**ADDENDUM #1**

**Will County Health Department**  
**BID PACKAGE #2 – Misc. Steel/Structural/Enclosure**  
**October 31, 2018**

### **2.04 DRAWING A501 - ENLARGED PLANS**

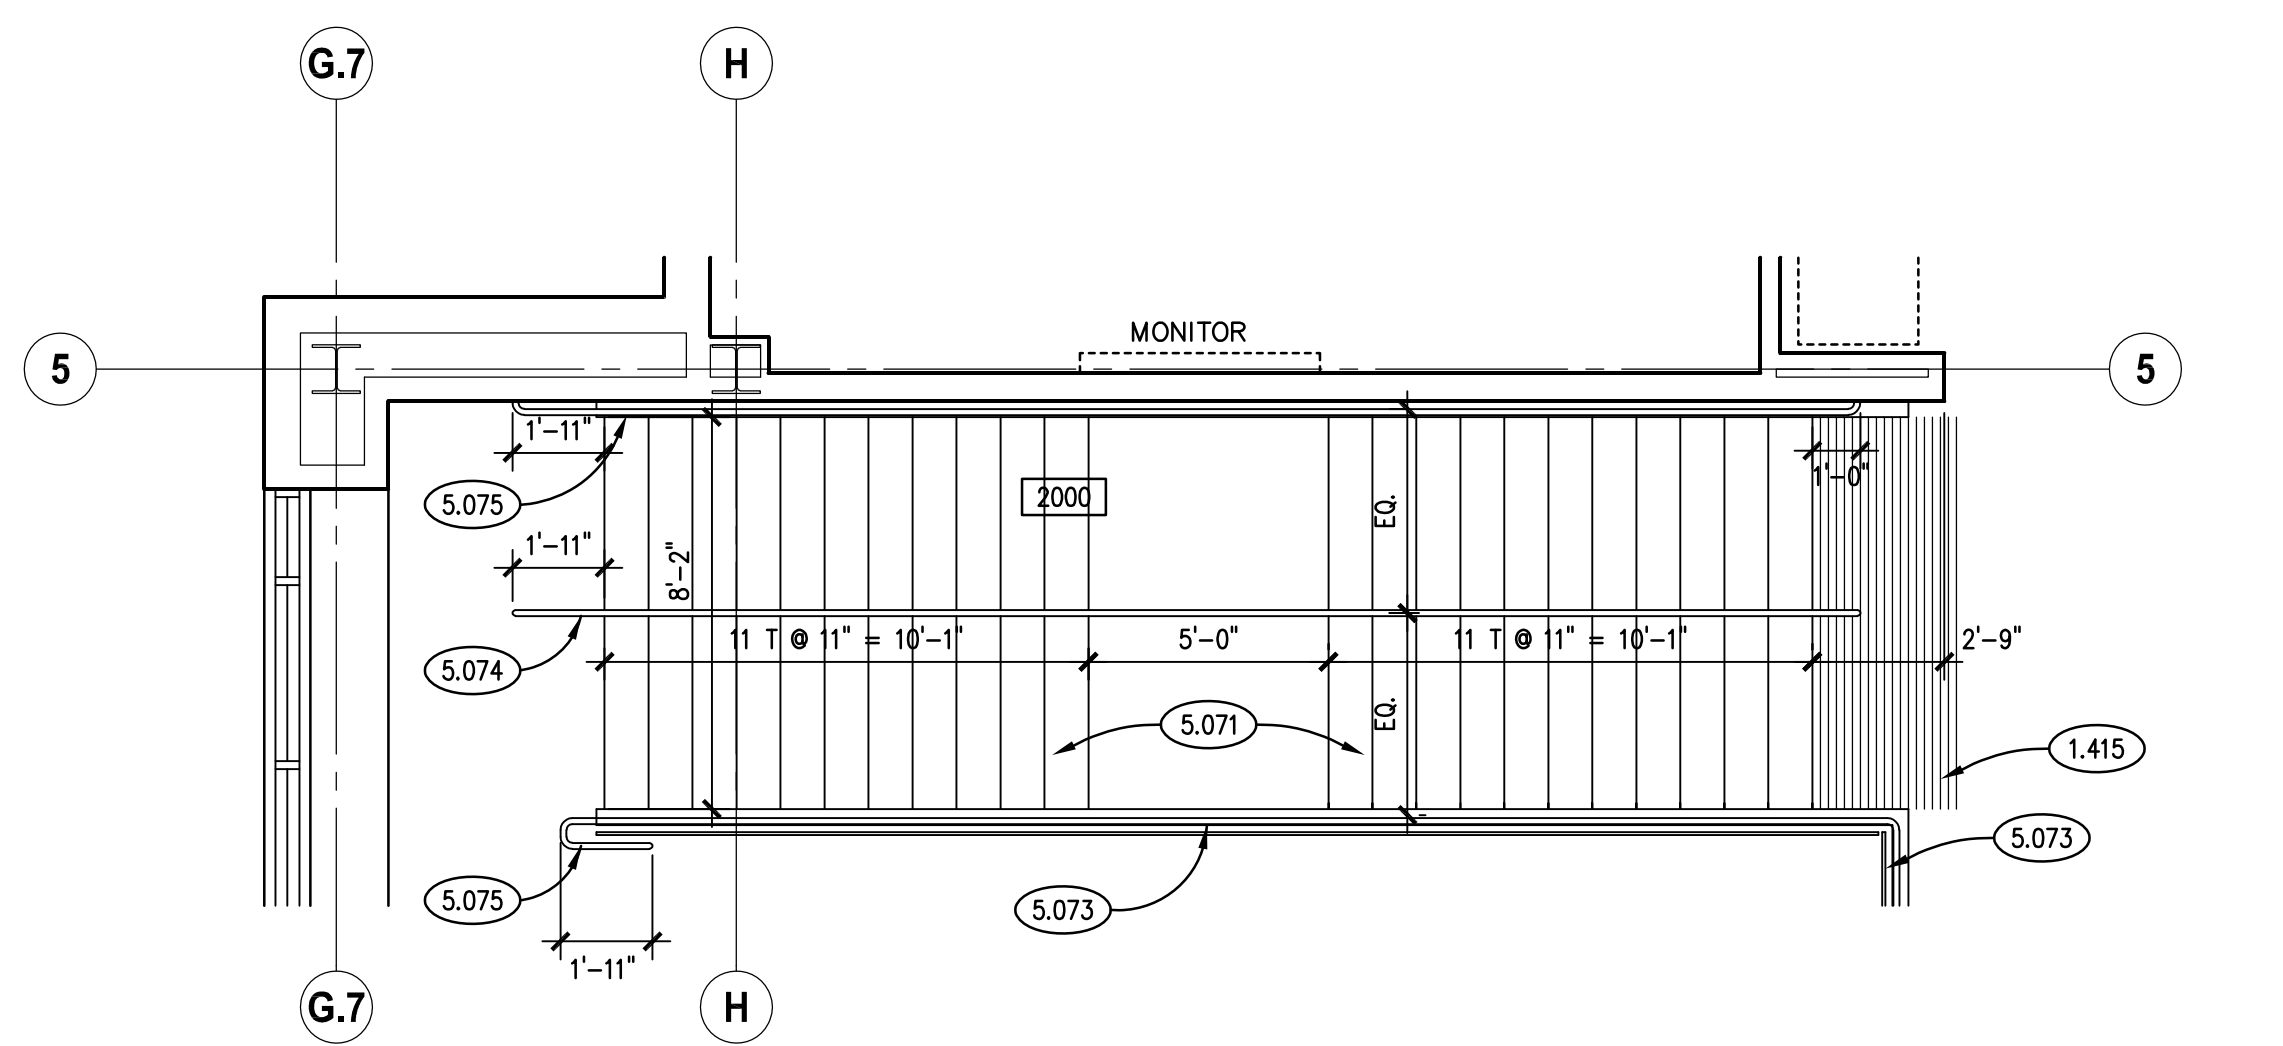
- A. Detail 1/A501 - East Stair - First Floor: Revise location of Door Opening 1310.11 leading to stairwell room number 1310 as indicated. Note: Door opening has been shifted south as indicated. No change to frame size.

- B. Detail 2/A501 - East Stair - Second Floor: Revise location of Door Opening 2294.1 leading to stairwell room number 2294 as indicated. Note: Door opening has been shifted south as indicated. No change to frame size.

- C. Detail 3/A501 - West Stair - First Floor: Added interior drywall at south wall as indicated.
- D. Detail 4/A501 - East Stair - Roof Level: Revise location of Door Opening 3294.1 leading to the roof from stairwell room number 3294 as indicated. Note: Door opening has been shifted south as indicated. No change to frame size.

- E. Detail 6/A501 - Trash Enclosure Plan: Add control joints and sealant to south wall of trash enclosure. Added Keynotes: 4.812, 4.813, 7.910 & 7.920

- F. Detail 7/A501 - Trash Enclosure Elevation "Rear": Add control joints and sealant to south wall of trash enclosure. Added Keynotes: 4.812, 4.813, 7.910 & 7.920.

## **2.05 DRAWING A700 - EXTERIOR BUILDING ELEVATIONS**

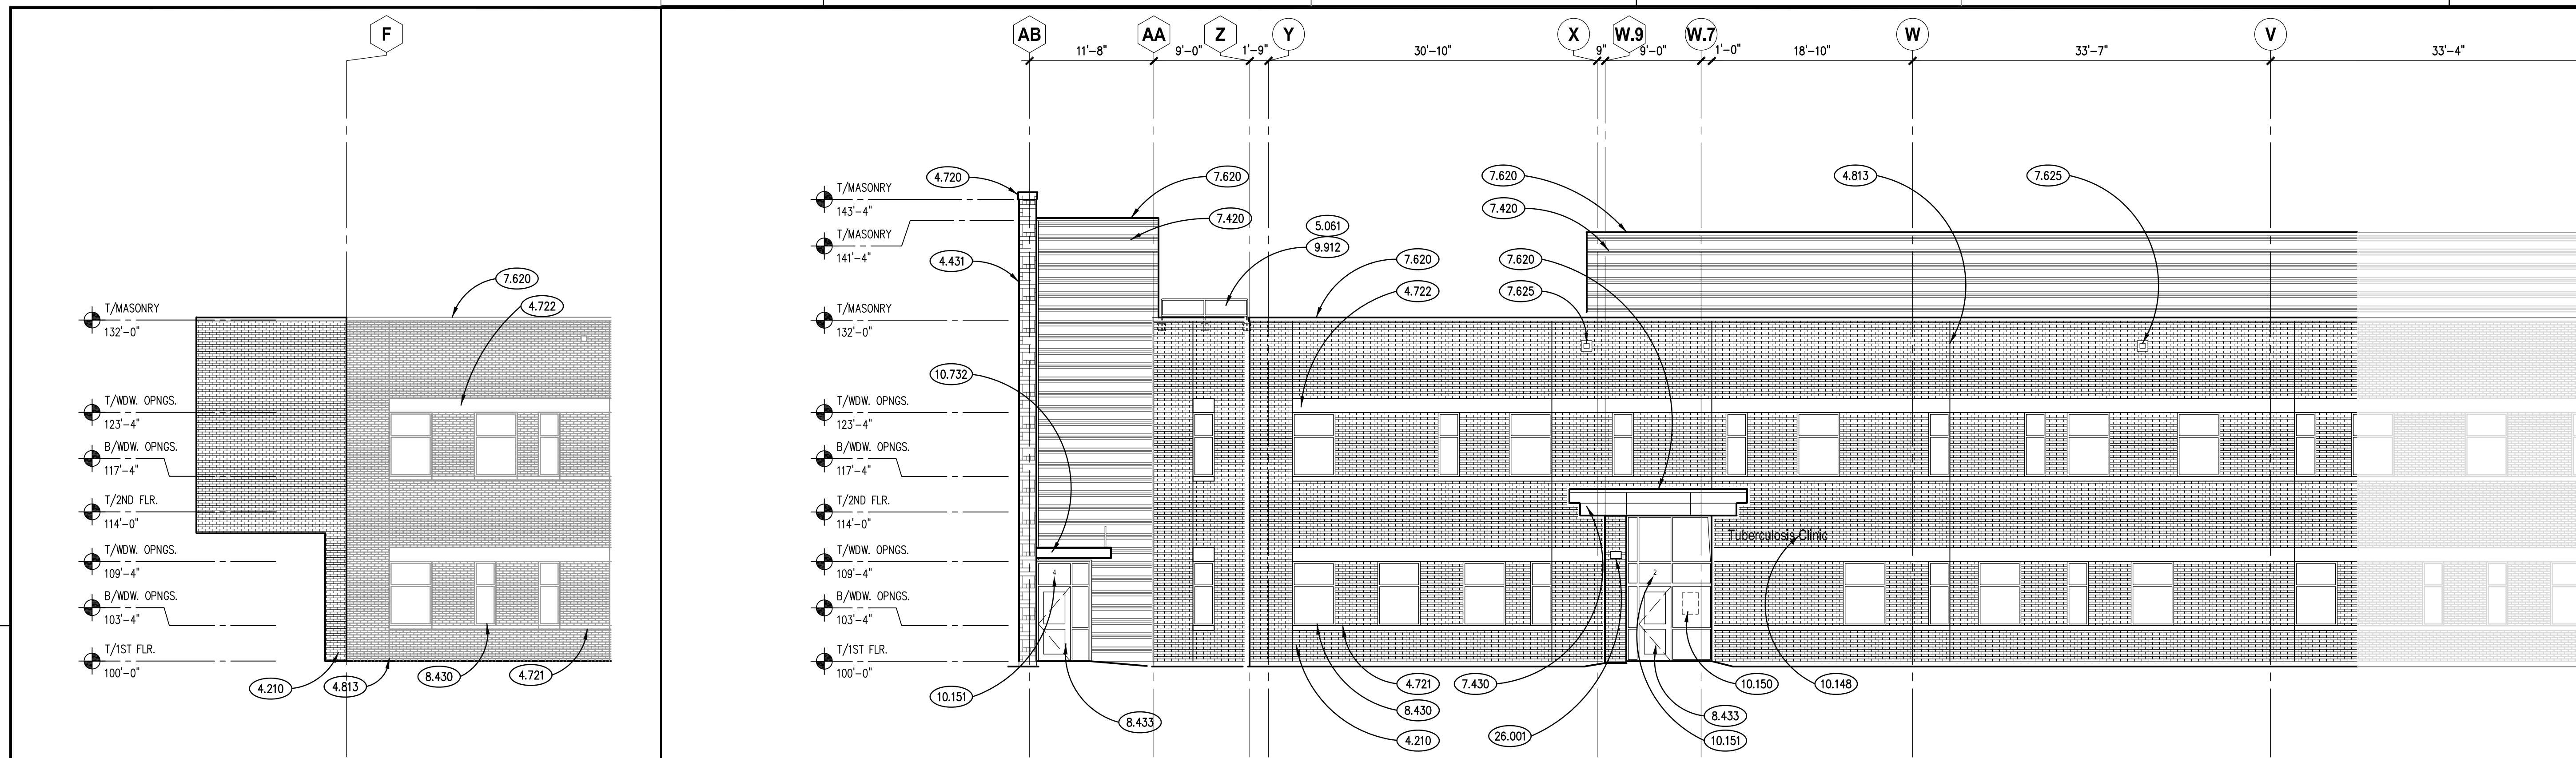
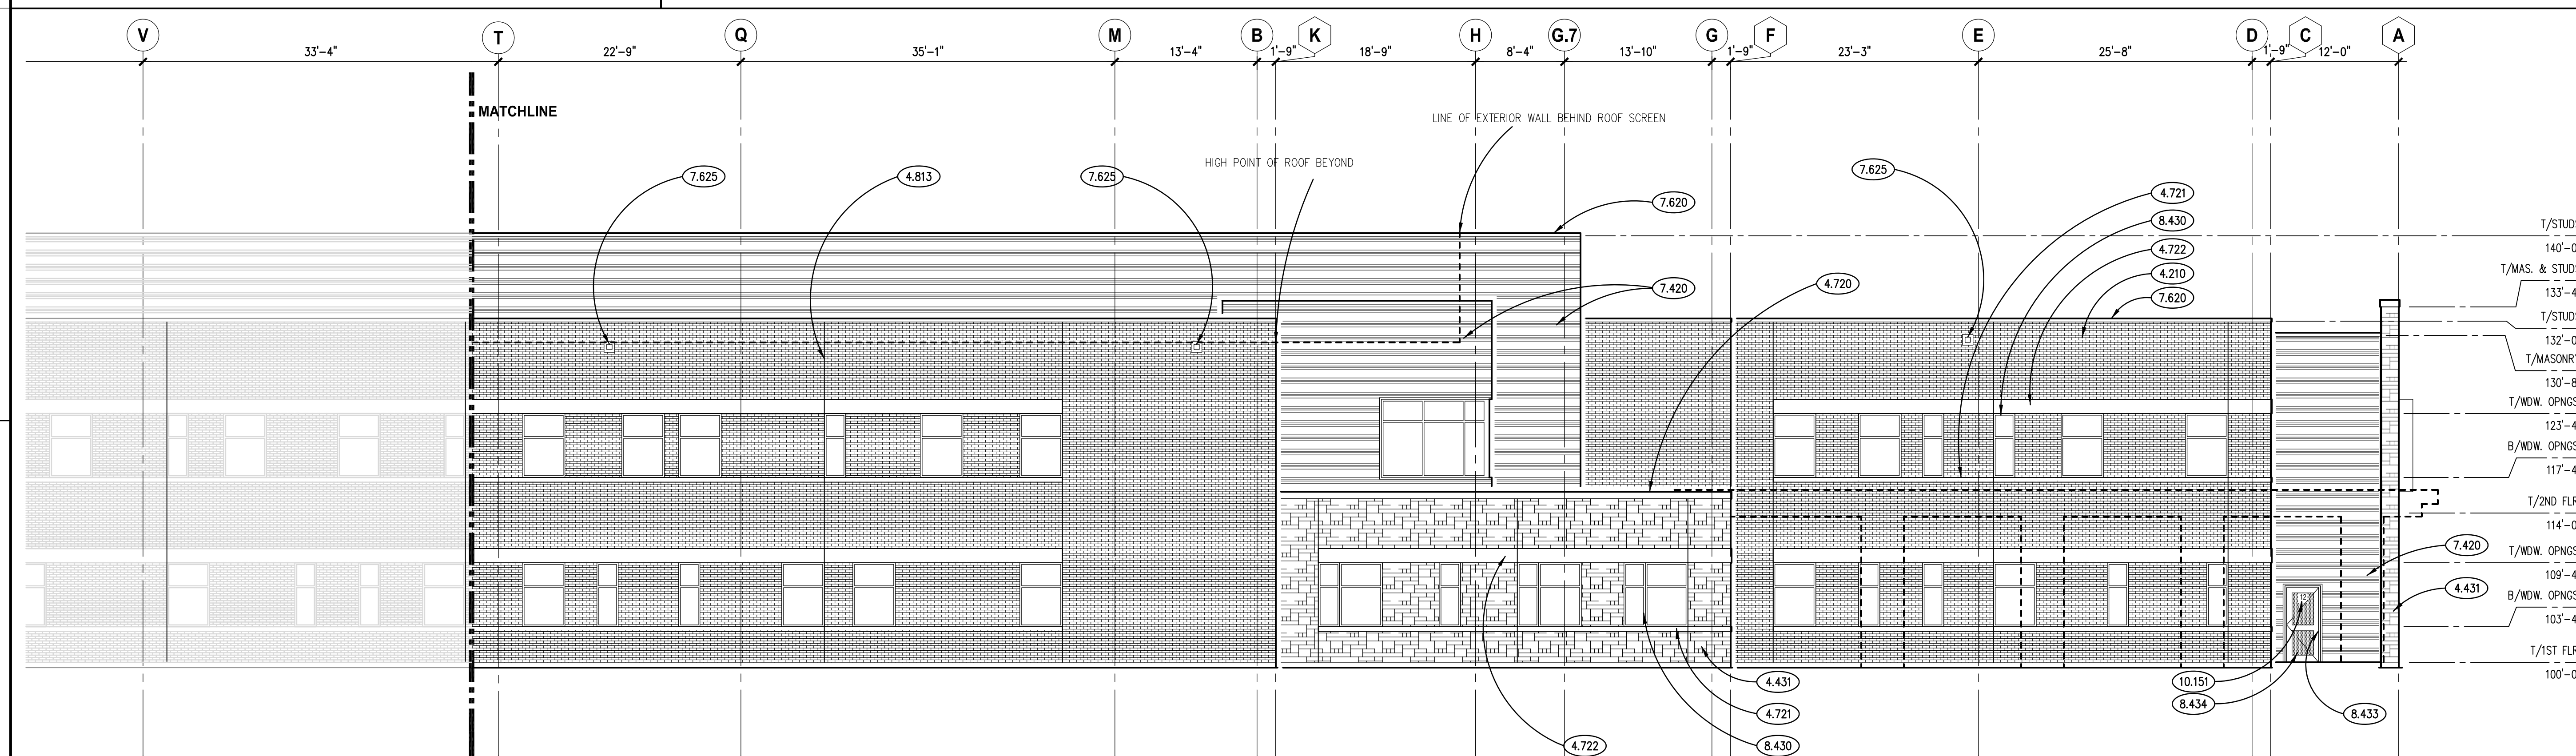
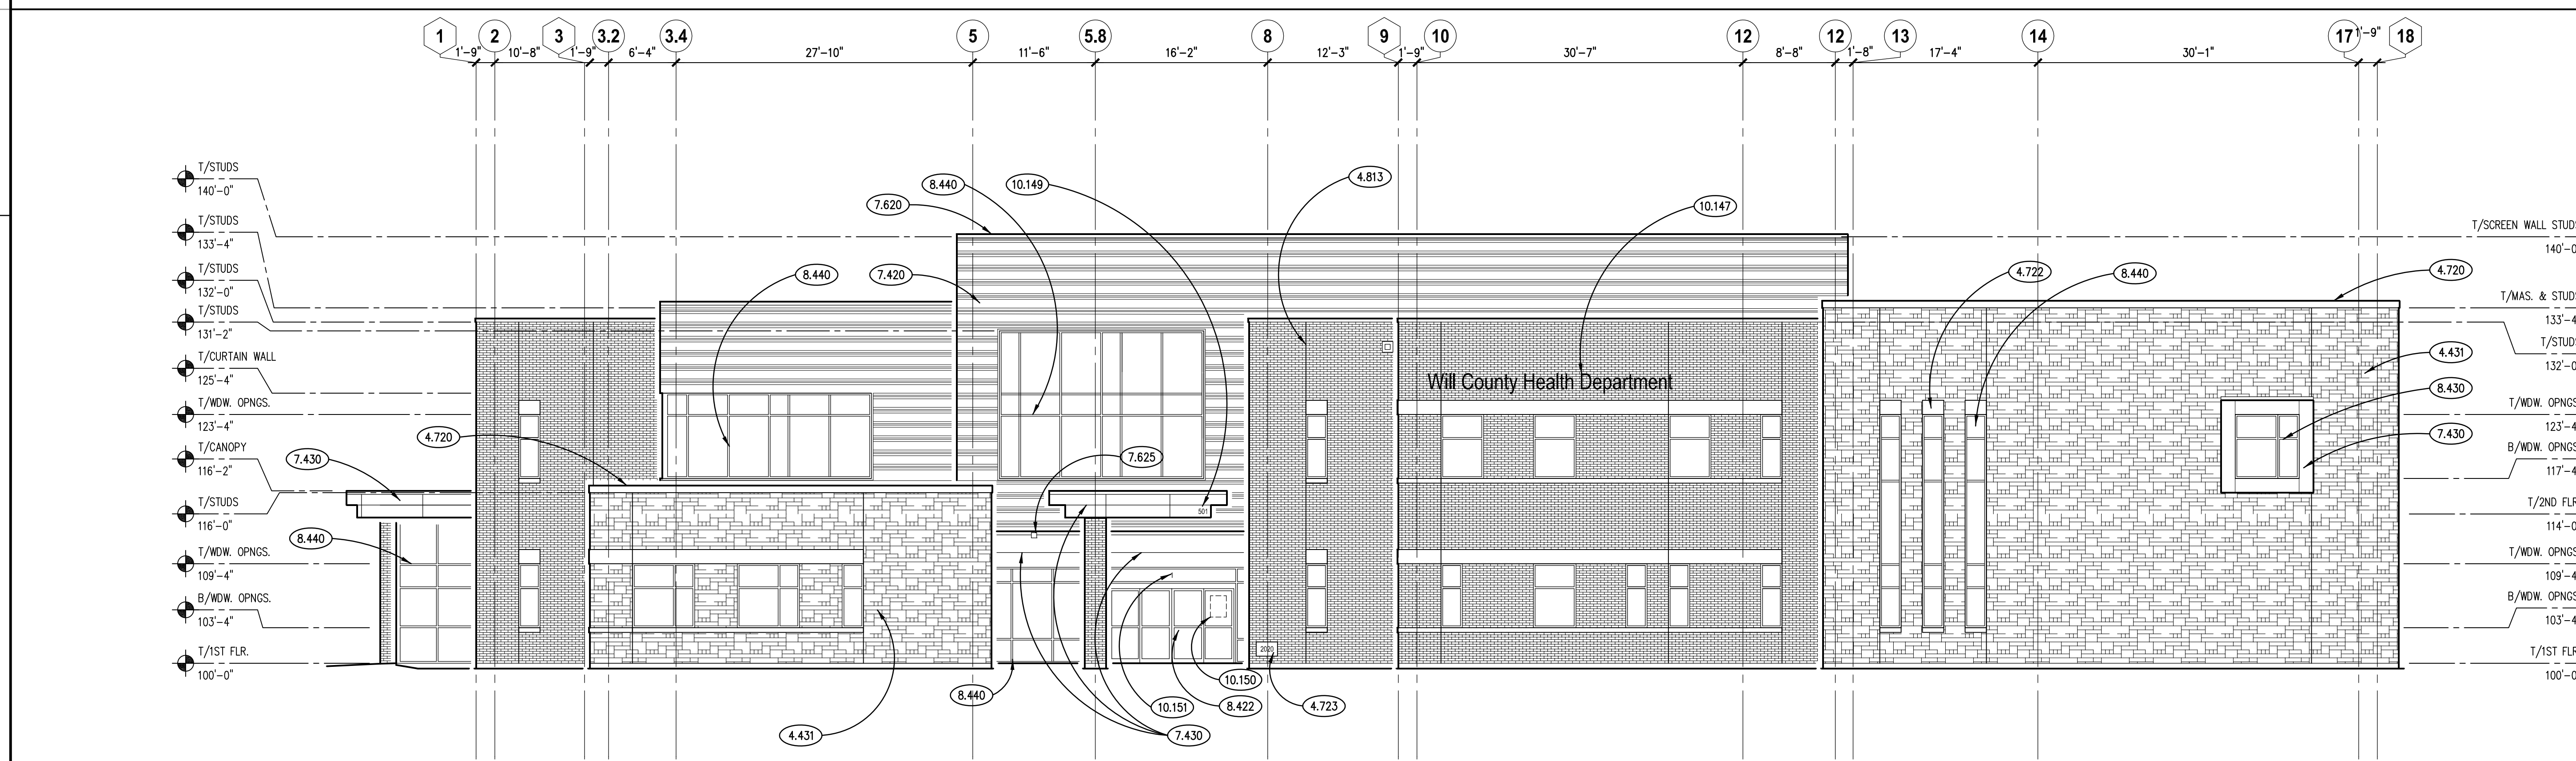
- A. Detail 4/A700 - Partial West Elevation: Revise location of Door Opening 1310.11 leading to stairwell room number 1310 from the roof as indicated. Note: Door opening has been shifted south as indicated. No change to frame size.
